Change Notification

(HT-202B Series)

2021.02.19

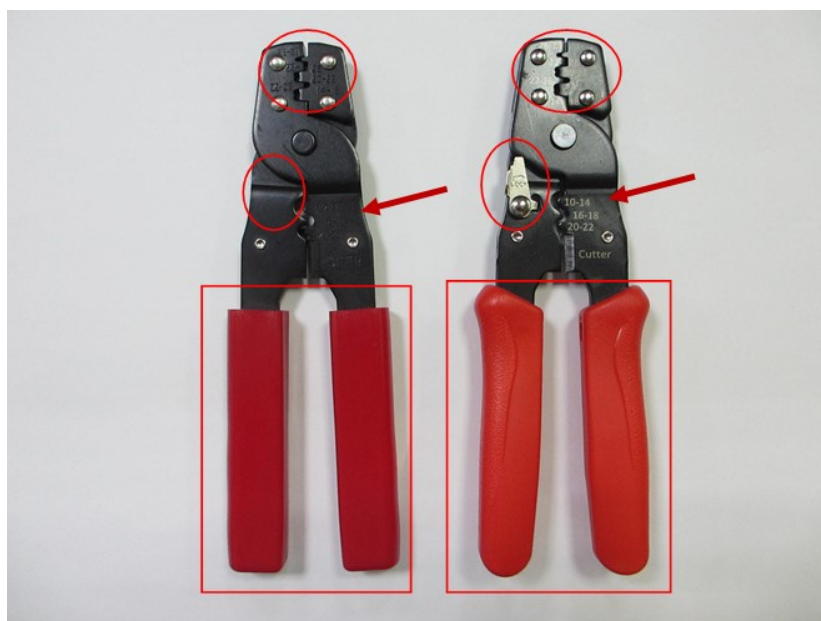
Change portion:

1. Change the shape of the handle.
2. Add Handle lock.
3. The specification marked on the front surface is change into laser-engraving version

Change reason:

1. The lifetime of the original handle tooling is over. Reopen a new tooling for this tool.
Change handle style and body appearance.
2. Add Handle Lock to improve operation and storage convenience
3. The specification marked on the front surface is change into laser-engraving version for easier identification.
